**City of Bellevue
Development Services Department
Land Use Division Staff Report**

Proposal Name: Palmer Preliminary Short Plat

File Number: 09-122554-LN

Department Decision: **Approval with Conditions**

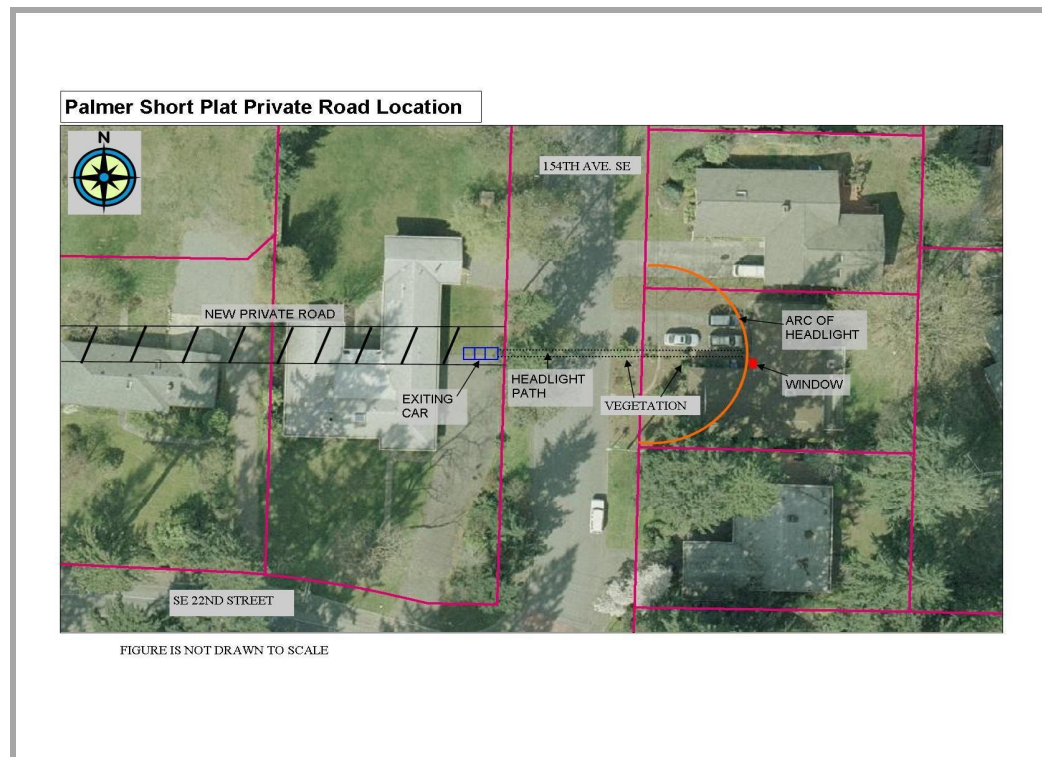
1. The proposal consolidates all traffic on to the 2000 block of 154th which currently has the highest traffic levels in the neighborhood due to its “collector” nature for the northern part of Robinswood and its straight thru connection to SE 16th. The neighborhood is already experiencing issues of traffic volume, excessive speed, pedestrian safety (due to lack of sidewalks) and commuter cut thrus. An additional six residences with multiple cars all using a common entrance on 154th will exacerbate the problem. It is unclear why the available arterial on SE 22nd is not used for some or all of the access.

The Palmer six lot short plat includes the removal of 2 existing houses. Therefore, there would be 4 new PM peak hour trips from the 6 lot short plat on the City roadway system. The added new daily trips from the proposed short plat is estimated to be 38 trips. These additional trips on the roadway system are not expected to have a significant influence on the existing traffic conditions. There is an existing traffic hump along 154th Avenue SE that provides traffic calming on the street. There are also patterned concrete entry treatments on 154th Ave SE which makes drivers aware that 154th Avenue SE is a local street.

City of Bellevue code 14.60.150.D states that the installation of driveways onto arterials may be denied if alternate access is available. The purpose of this requirement is to maintain the operational characteristics of each type of street as described in the Roadway Network section of the Comprehensive Plan and as specified in Policy TR-46. SE 22nd Street is classified as a collector arterial and 154th Avenue SE is classified as a local street. Therefore, for the Palmer short plat, the City will require access from 154th Ave SE.

City of Bellevue code 14.60.150.C encourages combined driveways for adjoining properties. Therefore, a private road which combines the access of the 6 lots is recommended as the access to the proposed short plat and will reduce conflicts that could otherwise occur if multiple driveways were allowed.

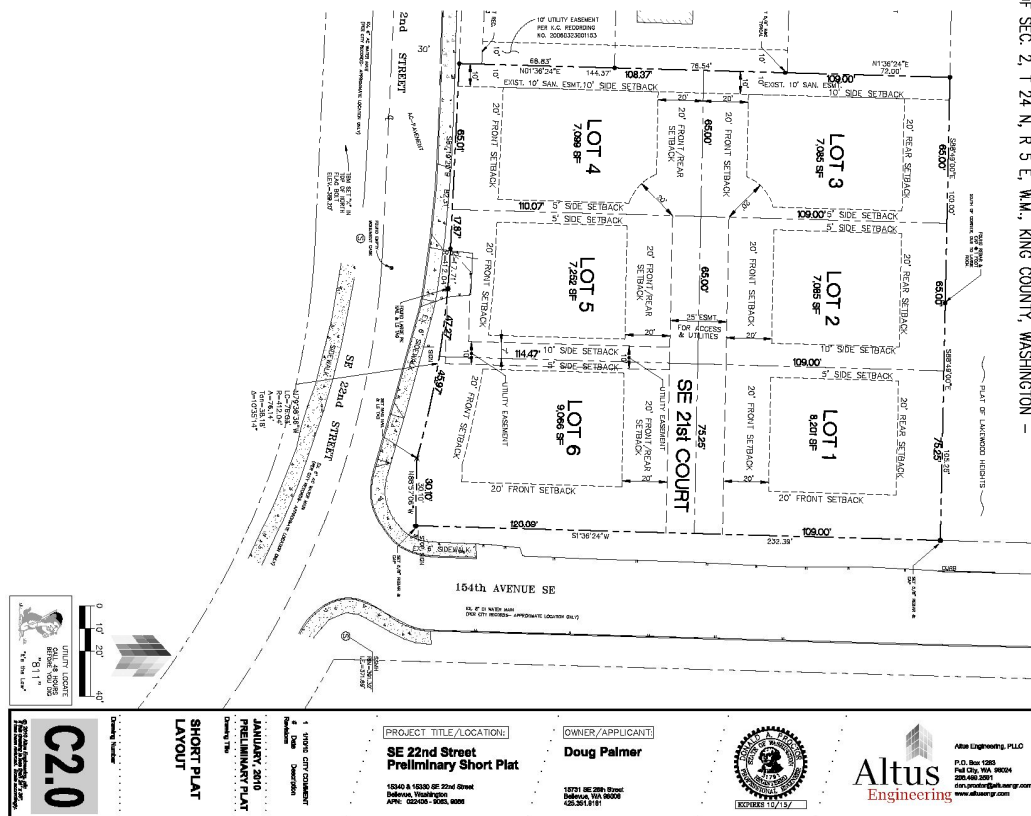
2. The proposed driveway orientation will cause the headlights of all exiting cars to shine directly into the residences on the east side of 154th. This is of serious and immediate concern to those residents.

The proposed private road entrance into 154th Avenue SE is opposite the garage of the house at 2056 154th Ave SE, located on the east side of 154th Avenue SE. There is one small entryway window in the house, approximately 2'x3' in size, which faces west toward the short plat driveway. Existing vegetation in front of the house, mostly screens the window from 154th Avenue SE. The headlights of exiting cars are not expected to significantly impact the residents of the house on the east side of 154th Ave SE. See figure below:
